Re: Map of Willow View Estates Proposed 284-lot Subdivision
99 Meadow Drive, Woodmere / Village of Lawrence / Village of Woodsburgh
DEIS Comments
CE 2735

Cameron Engineering & Associates, LLP has reviewed the Willow Estates Subdivision Draft Environmental Impact Statement (DEIS) dated May 2020, and on behalf of the Town of Hempstead, Village of Lawrence, and Village of Woodsburgh, offers the following technical comments on the DEIS.

Below is an excerpt of traffic study Figure 3; the dotted line circle shows the approximate location of the new site access to Broadway, at Lotus Street.

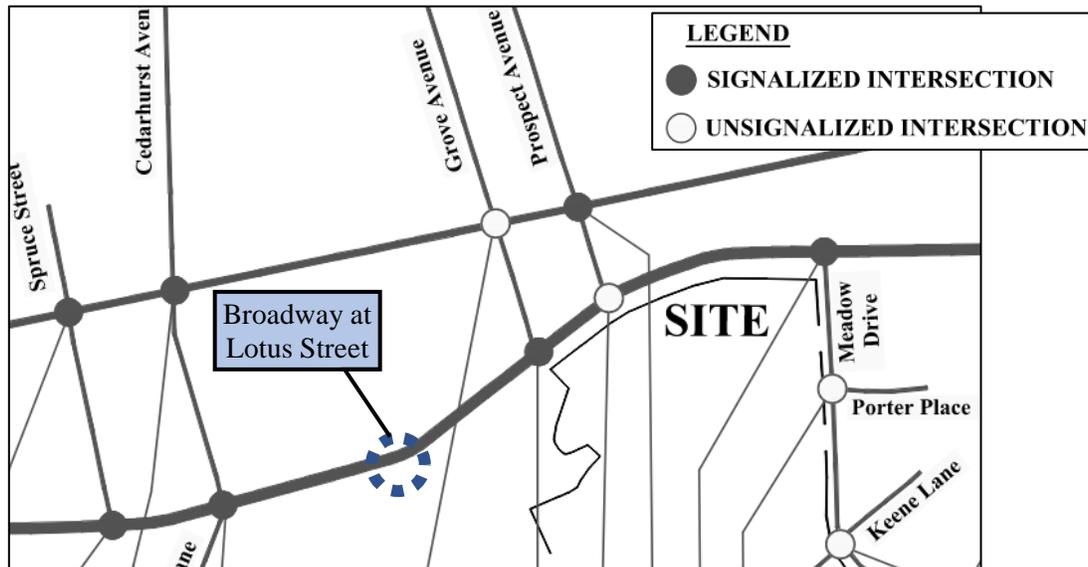
- Comment 2.** The DEIS traffic study does not include the intersection of Pine Street with Broadway. This intersection would likely be utilized to access Central Avenue, and should have been included as a study intersection.
- Comment 3.** The traffic study is deficient in avoiding the discussion/analysis of changing a residential dead-end street (Tulip Street) into a through street that will connect this subdivision to Broadway.
- Comment 4.** The traffic study notes multiple site driveways: connections to Tulip Street and Keene Lane, in addition to connecting to Meadow Drive and a new access on Broadway across from Prospect Avenue.

The traffic study does not study the proposed driveway connections to Tulip Street and Keene Lane, nor does it study the intersection of Broadway-Lotus Street which would receive all traffic associated with the proposed Tulip Street driveway extension.

The traffic study is also deficient by not providing any figures which depict every site access in the context of the traffic volume figures. The public needs to be readily able to discern where each new access will be, relative to the existing road network.

The Build scenario traffic volume figures also need to depict every driveway's traffic volume.

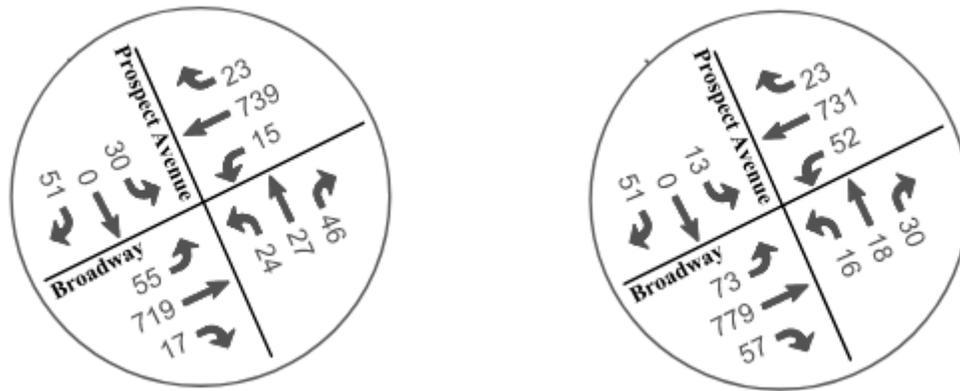
Comment 5. The traffic study uses 24-hour Automatic Traffic Recorder data obtained from [Friday] May 18, 2018 to [Friday] May 25, 2018 on Broadway and on Meadow Drive. The Broadway ATR data was used for a traffic signal warrant study of Broadway and Prospect Avenue (“the average of five weekdays of data”).

However, this 7-day period was inappropriate for traffic data collection. The Jewish holiday of Shavuot is one of the three major festivals in Judaism, and Shavuot began Saturday night, May 19, 2018 and ended Monday night, May 21, 2018. The traffic study even explains that the surrounding community has a large population of observant Jews who do not drive on the Jewish Sabbath (Saturday), such that Sunday is the busier weekend day for traffic analysis. The ATR data comprises a major multi-day Jewish holiday, so the data does not represent typical (non-holiday) conditions and the traffic signal warrant study is invalid.

Of note, the invalid data comprises more than just the Sunday and Monday of the holiday; the preceding Friday and subsequent Tuesday would almost certainly have been atypical as well. Observant Jews who refrain from driving on Saturday, typically drive more on Friday before the Sabbath begins, and on Sundays. The traffic counts in this DEIS study, as well as Cameron Engineering in-house data and publicly available municipal database counts, confirm this pattern in Orthodox communities. However, pre- and post-holiday traffic surges are highest when a holiday like Shavuot begins on Saturday night, immediately after the end of Sabbath observance. There is more activity on the preceding Friday than a typical Friday, and the first one to two weekdays after the holiday ends are busier than a typical Sunday.

Below are excerpts of traffic study Figure 11-Trip Distribution:

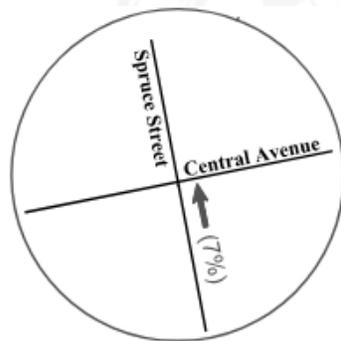
It can be inferred from the arrow diagrams in Figure 11 (but it is not expressly stated, and the traffic study should do so) that 7% of trips would be destined for the Cedarhurst LIRR station (via Spruce Street), and that 14% of trips would be destined for the Woodmere LIRR station. This equates to 21% of traffic destined for the LIRR – even on weekends – which is too high for weekend and weekday peak hour periods.

- a. *7% presumed to represent distribution to Cedarhurst LIRR*

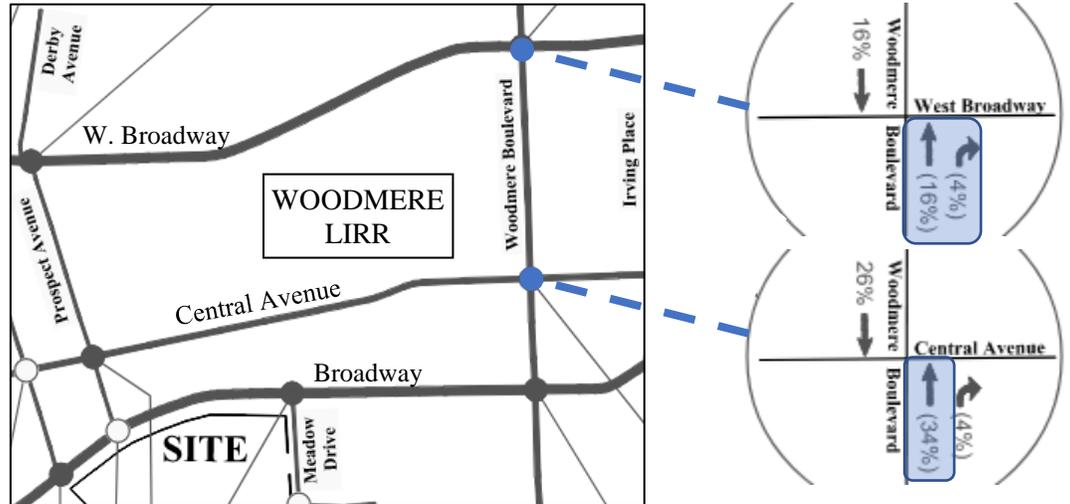
- b. *14% presumed to represent distribution to Woodmere LIRR (the difference between 34% northbound through Central Avenue, and 20% approaching W. Broadway)*

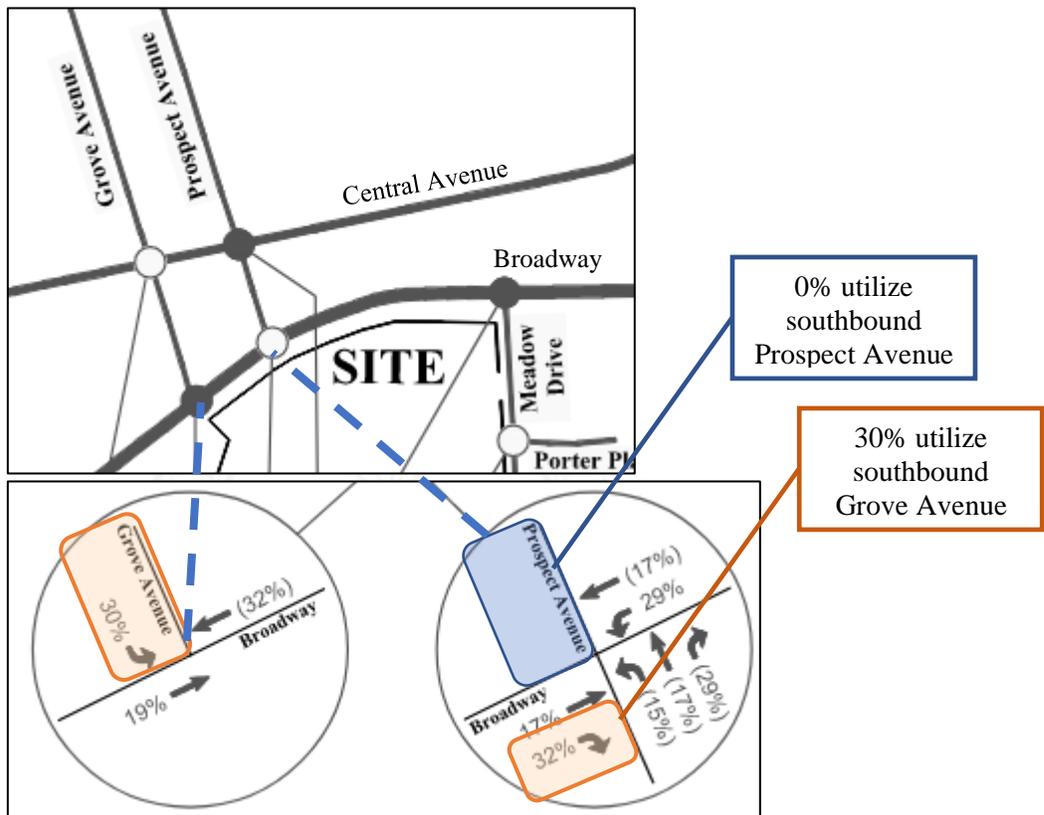
- It does not seem realistic that no one (i.e., 0% of trips) would utilize southbound Prospect Avenue to head directly into the property via the proposed driveway. Instead, the traffic study assigns trips to southbound Grove Avenue, then a left on Broadway and right into the driveway. This concern also undermines the traffic study’s signal warrant analysis, in that not enough traffic is assigned to Prospect Avenue.

- The study’s exiting trip distribution may not comprise 100% of site trips, based on numbers depicted in Figure 11.
 - 41% of trips head west, then north via Rockaway Turnpike-Burnside Avenue
 - 4% of trips head west, then south via Rockaway Turnpike
 - 7% of trips head up Spruce Street, presumably to the Cedarhurst LIRR
